Planning Justification Report - Addendum

Zoning Bylaw Amendment & Draft Plan of Subdivision

Village of Alma

June 4, 2024

Figure 1 - Key Changes from 1st Submission

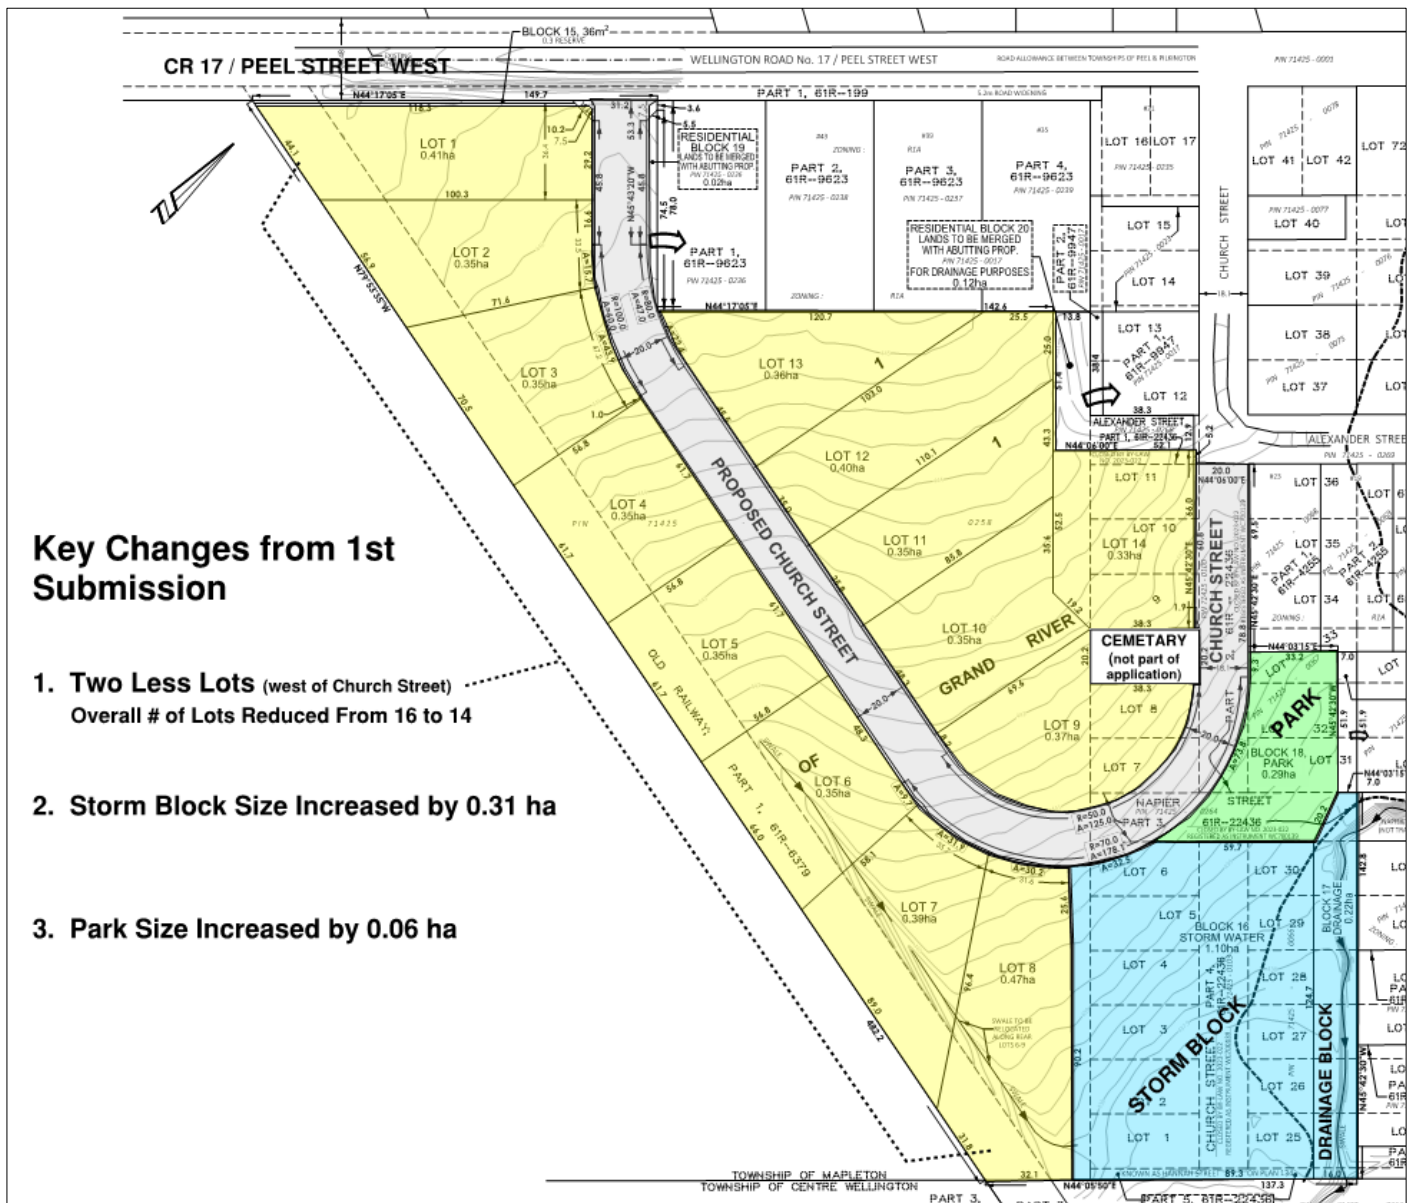
As shown on Figure 1 the key changes between the 1st Submission and 2nd Submission versions of the Subdivision Plan are:

- the number of lots fronting on the south-west side of the Church Street extension has been reduced from ten (10) lots in the 1st Submission to eight (8) lots in the revised version of the plan (below). Overall, the number of lots has been reduced from a total of 16 to a total of 14
- the size of the storm water management parcel (pond et al) has been increased by 0.31 hectares, and
- the size of the park block has been increased by 0.06 hectares.

Figure 3 - Proposed Zoning

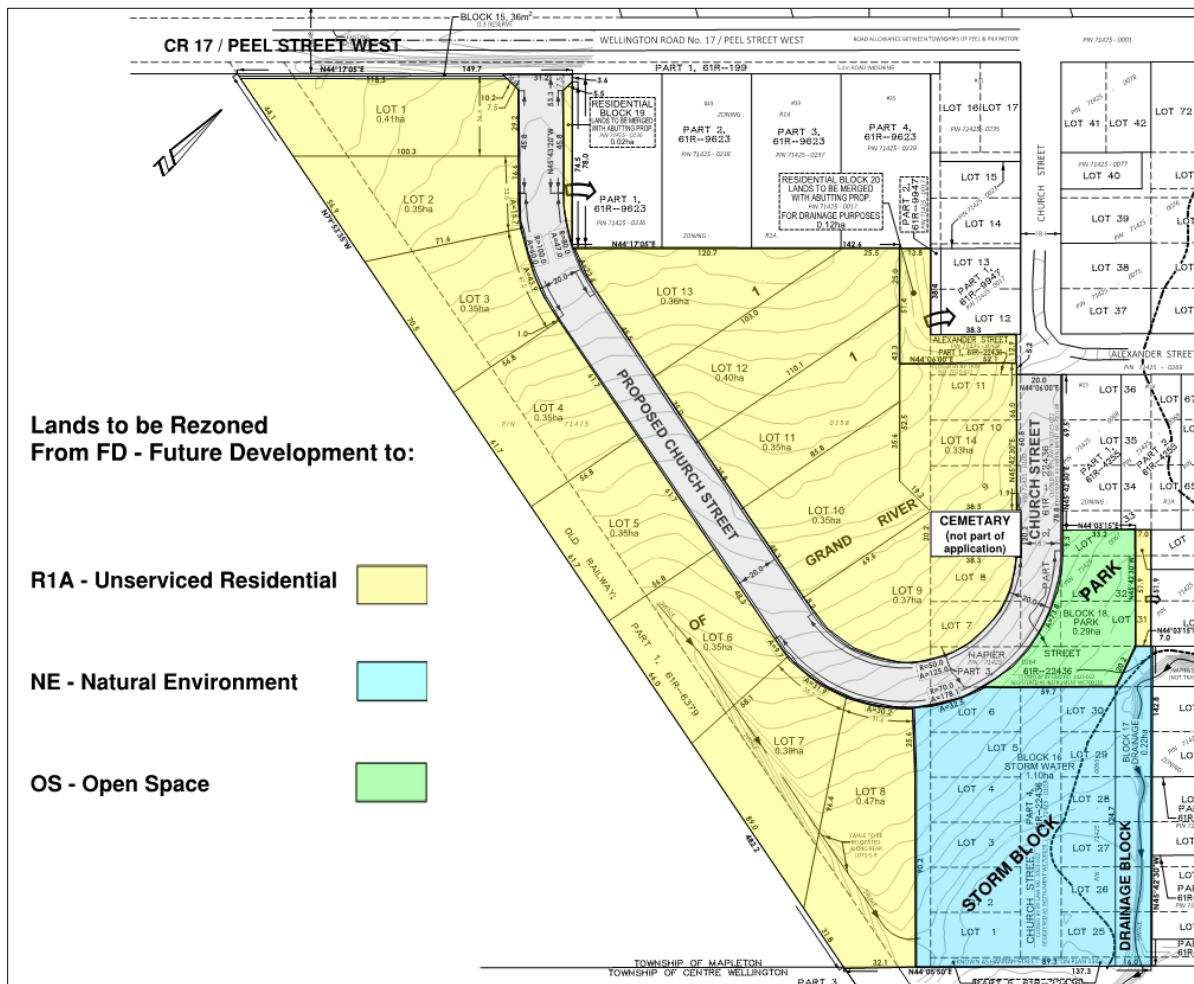
The proposed park will be re-zoned from FD to OS1 – Open Space, and the stormwater management and drainage block will be re-zoned from FD to NE – Natural Environment. The proposed zoning is shown on Figure 3.
